Loop 303/White Tanks ADMPU Area Hydrologic Analysis in
Maricopa County, Arizona

Flood Control District of Maricopa County

Version 1.2 / September 2009
HDR Project No. 079902
FCD Contract No. 2007C031

To: Valerie A Swick – FCDMC Project Manager
From: Guihua Li/Gary Sun - PB
Date: June 24, 2009
Project: Loop 303/White Tanks ADMPU Area Hydrologic Analysis
Subject: Comments on HDR's June 2009 Revised Figure 4 (Future Facilities) and New Figure (2017 Facilities)

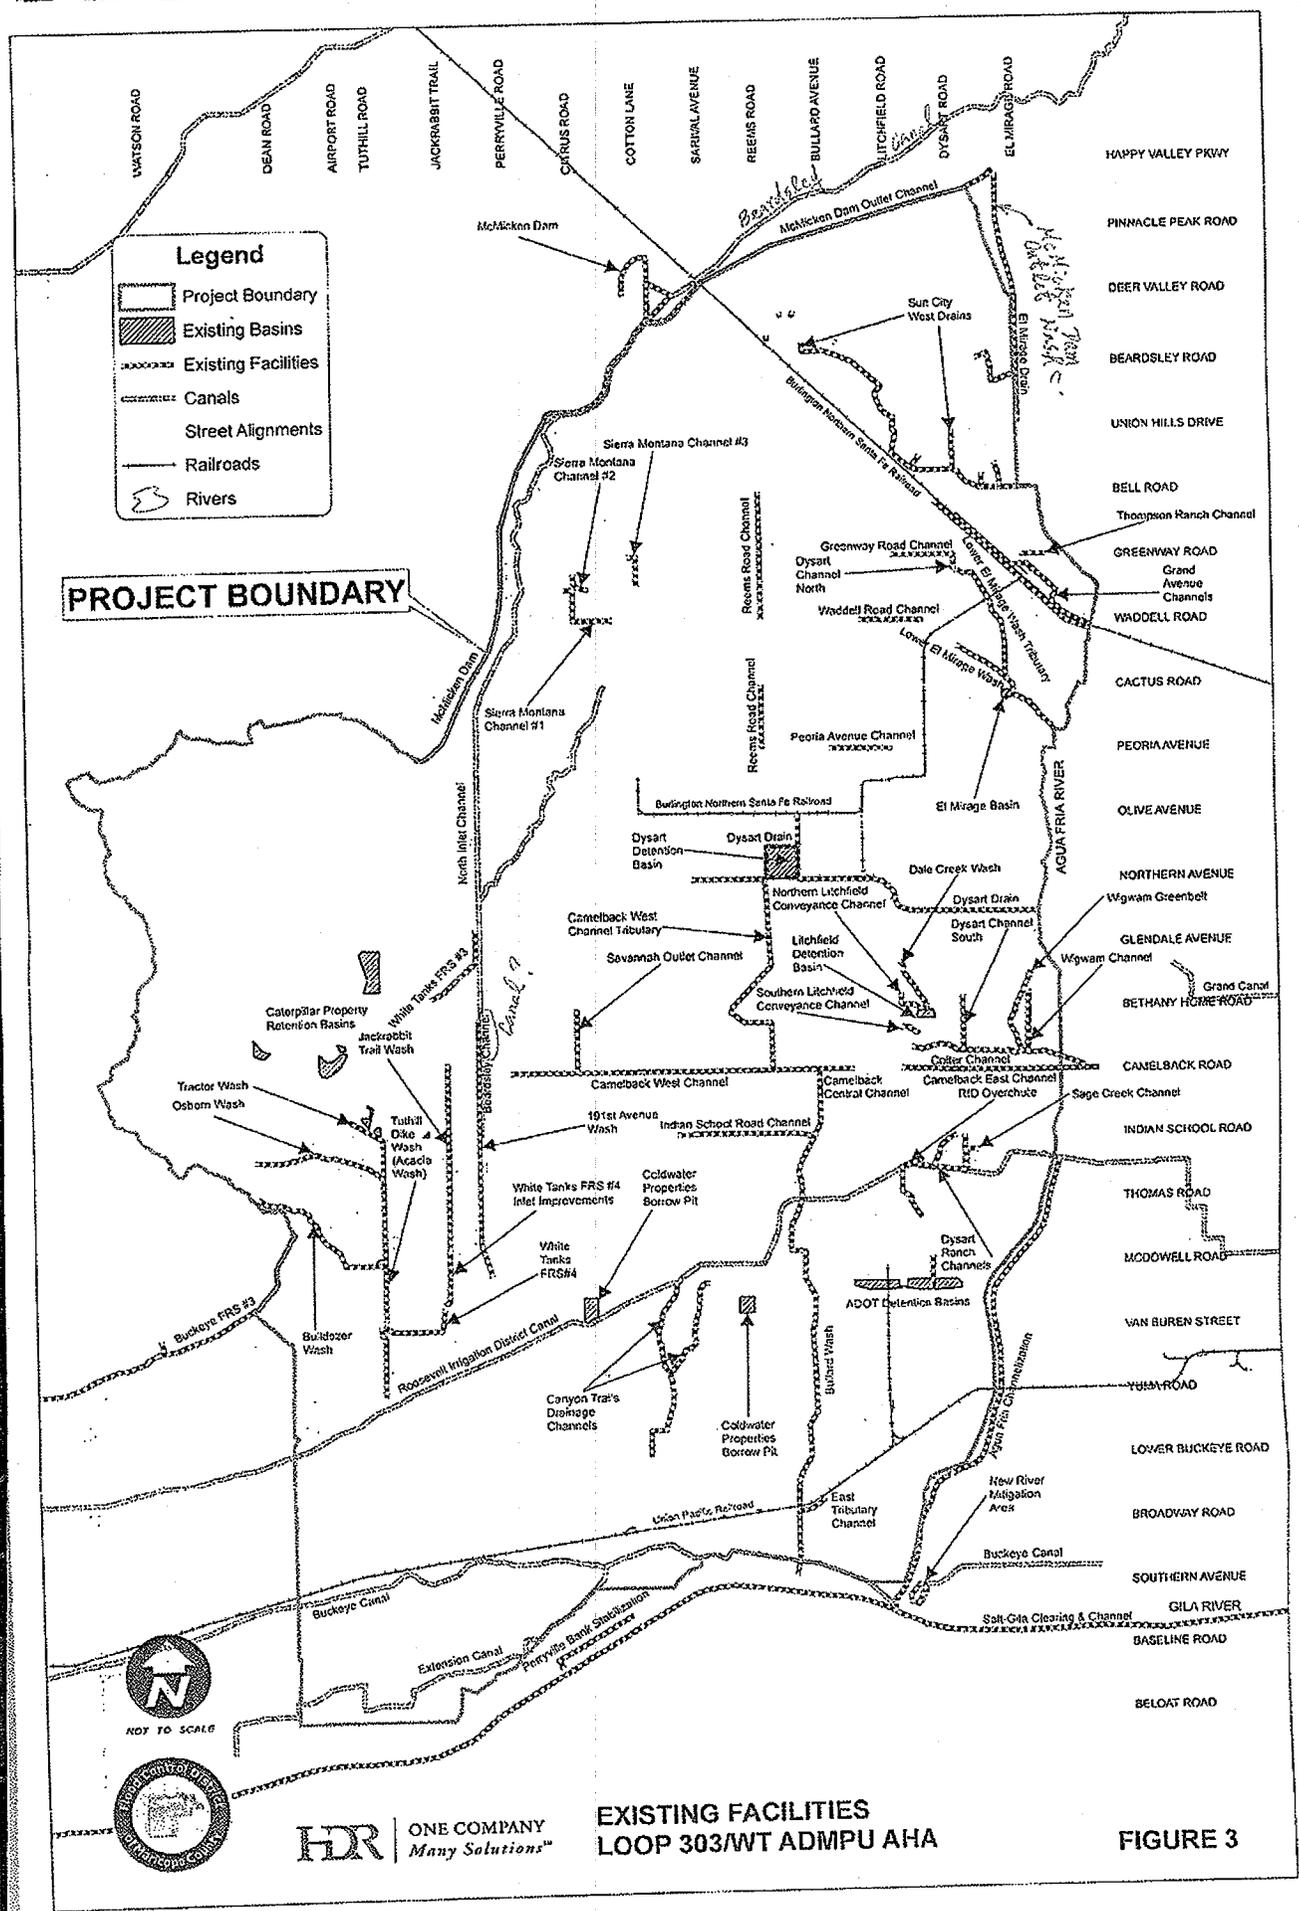
2. Figure 3 – Existing Facilities (See attached redlines):

- Label McMicken Dam Outlet Wash.
- Verify "Beardsley Channel". Is it "Beardsley Canal"?

61		Label significant land marks: LAFB, Goodyear Airport, PIR	PB for ADOT	Will comply.
62		Legend: Add a legend for DAM	PB for ADOT	Will comply.
63	2	Figure 3-Existing Facilities Map: Label McMicken Dam Outlet Wash	PB for ADOT	Will comply.
64		Verify "Beardsley Channel" Is it Beardsley Canal?	PB for ADOT	Will comply.
65	3	Figure 4 Future Facilities Map: Move the Legend box for clarity	PB for ADOT	Will comply.
66		Label all existing features as shown on Fig 3	PB for ADOT	Will comply.
67		What is the CIP facility shown south of LAFB? Why is it not shown on Figure X for 2017 Facilities	PB for ADOT	This is part of the LAFB Drainage Improvements. It is a channel and then improvement of Bullard Wash to Camelback. It is not anticipated to be constructed by 2017.
68		There is a basin located just north of the proposed Bullard Wash Channel. Is there a name for this basin?	PB for ADOT	This basin will be labeled. It is the 1-10 Bullard Wash Basin

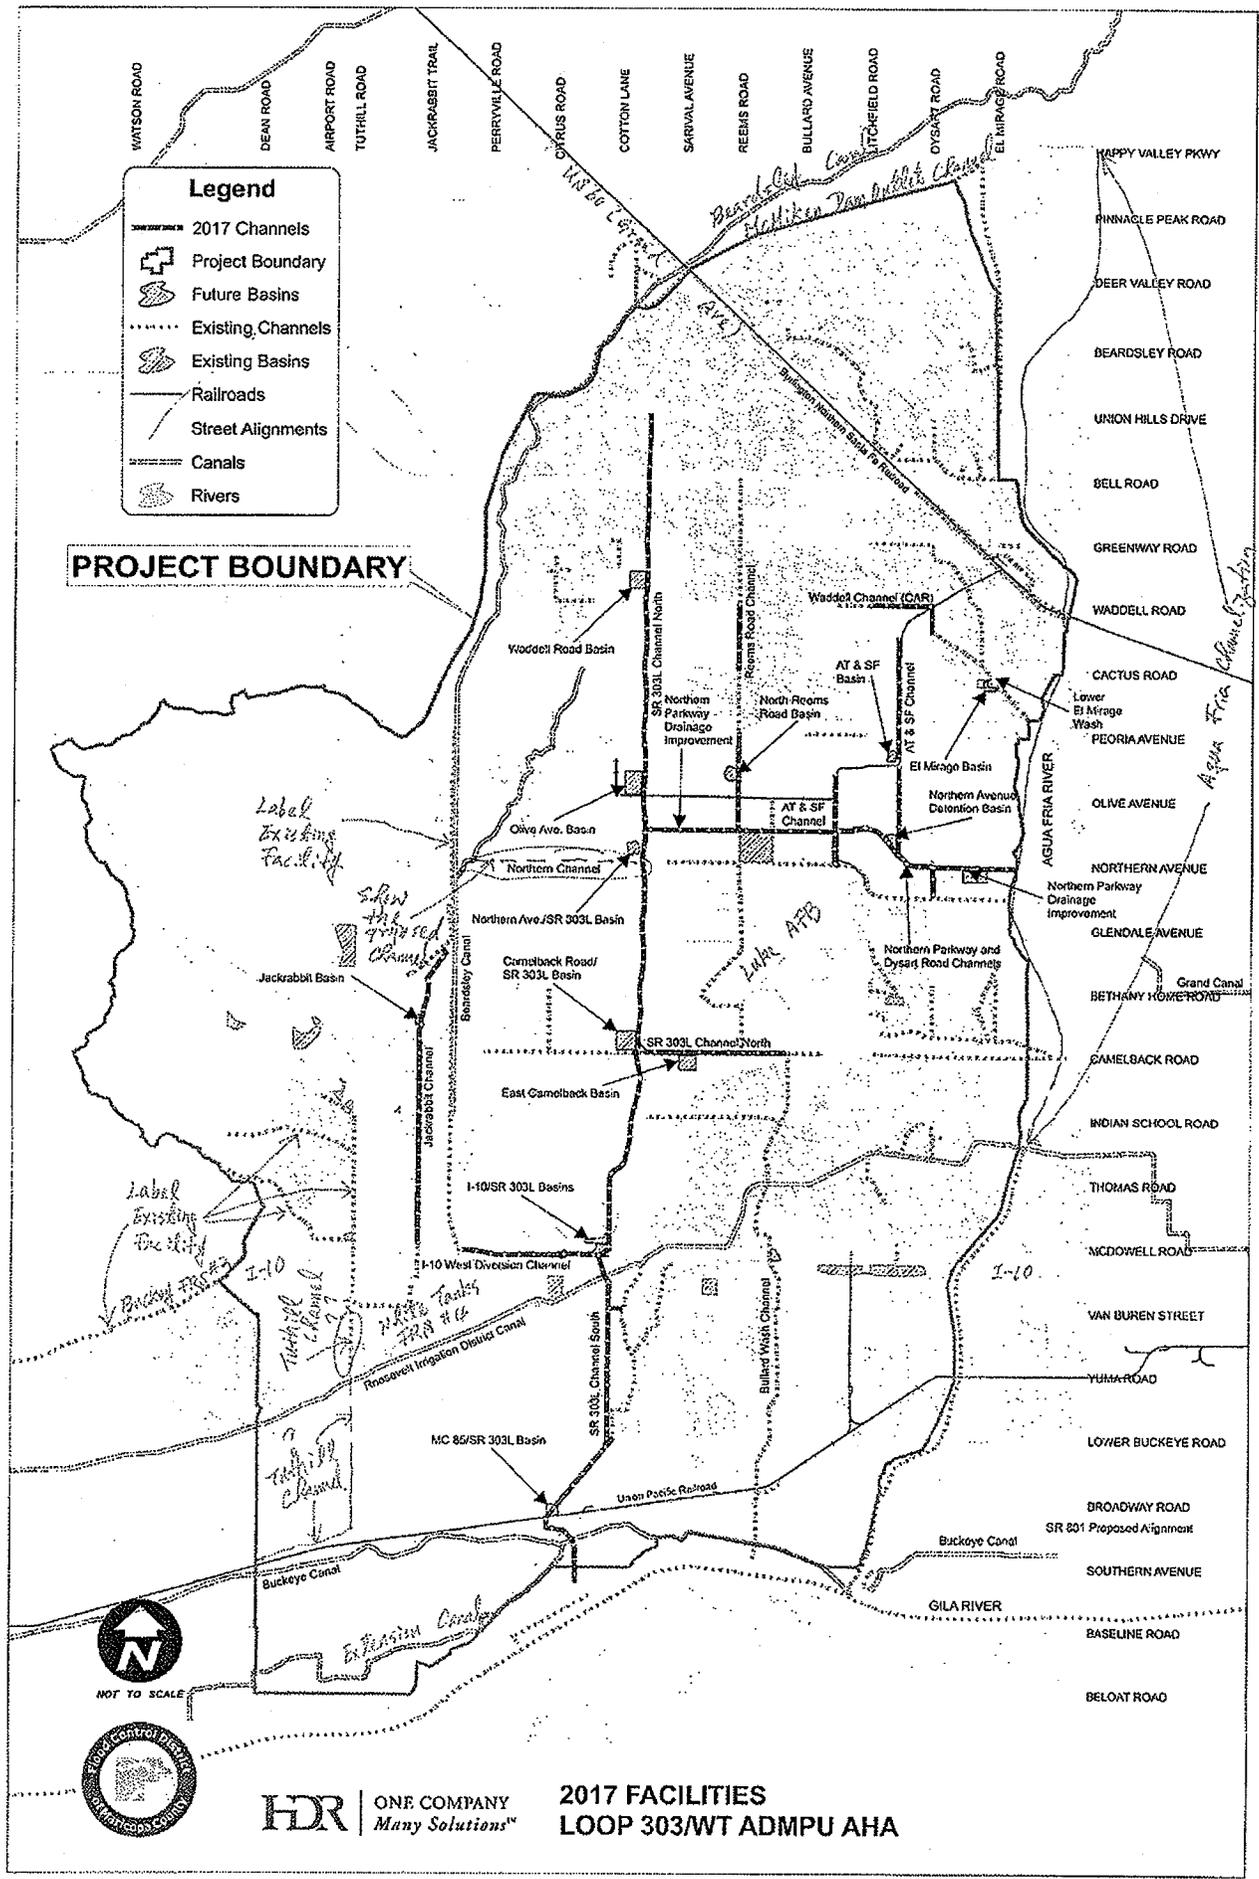
3. Figure 4 – Future Facilities (See attached redlines):

- Move the Legend box for clarity.
- Label all existing features as shown on Figure 3.
- What is the CIP facility shown south of LAFB? Why it did not show on Figure X for 2017 Facilities?

- There is a basin located just north of the proposed Bullard Wash Channel. Is there a name for this basin?
- Based on the discussions between ADOT and FCDMC, the SR303L Channel South and MC85/SR303L Basin will be constructed by FCDMC around 2015, definitely by 2017. ADOT will complete the I-10/SR303L T.I. Phase I construction prior 2017. Some segments of SR303L and drainage systems will be completed by 2017. Show these completed facilities as existing facilities on Figure 4.

Sketch for comment # 4

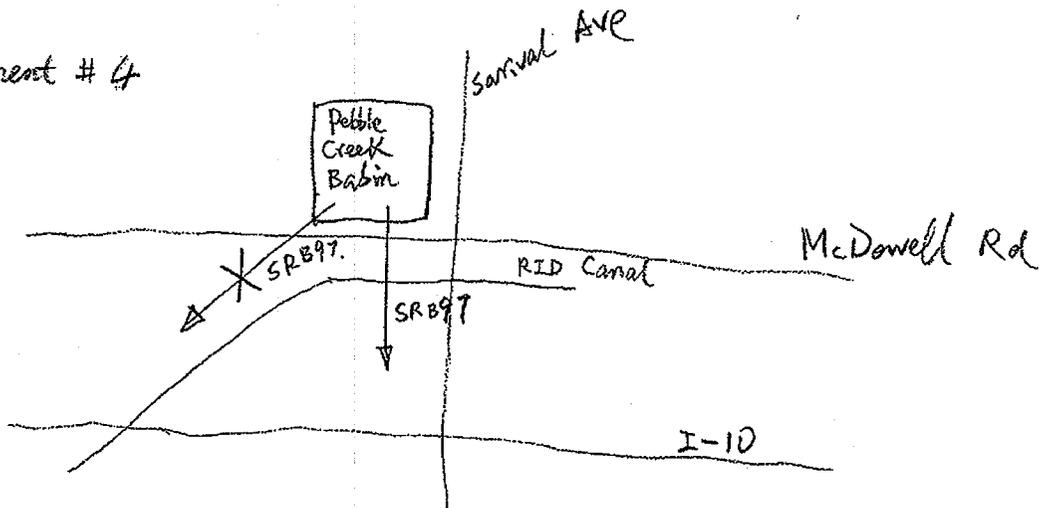
- There were only 3 features were shown differently from Figure 4 – Future Facilities. They are Tuthill Channel, Bullard Wash Channel and the proposed CIP facility south of LAFB.
- Why the proposed Tuthill Channel was shown differently from Figure 4?
- Why the proposed CIP facility south of LAFB did not show on this Figure?
- The line for the proposed Northern Channel is missing.

73	4	Figure X-2017 Facilities: There are only 3 features were shown differently from Figure 4-Future Facilities. They are the Tuthill Channel, Bullard Wash Channel and the proposed CIP facility south of LAFB.	PB for ADOT	Yes. Those are the only projects projected not to be built by 2017. This was determined by interviews with the FCDMC and other stakeholders.
74		Why the proposed Tuthill Channel was shown differently from Figure 4?	PB for ADOT	Because the Tuthill channel will not be built by 2017.
75		Why the proposed CIP facility south of LAFB did not show on this Figure?	PB for ADOT	Because the LAFB improvements will not be built by 2017
76		The line for the proposed Northern Channel is missing.	PB for ADOT	Will add.
COMMENTS BY PB JUNE 24, 2009-REVISED FIGURE 4 AND NEW FIGURE (2017 FACILITIES)				
77	1	Percent of impervious area (RTIMP) is the percent of sub-basin which is impervious. RTIMP used (78%-88%) in the HEC-1 LG records were too high.	PB for ADOT	RTIMP was based on land use parameters in District manual based on projected land use. No change will be made.
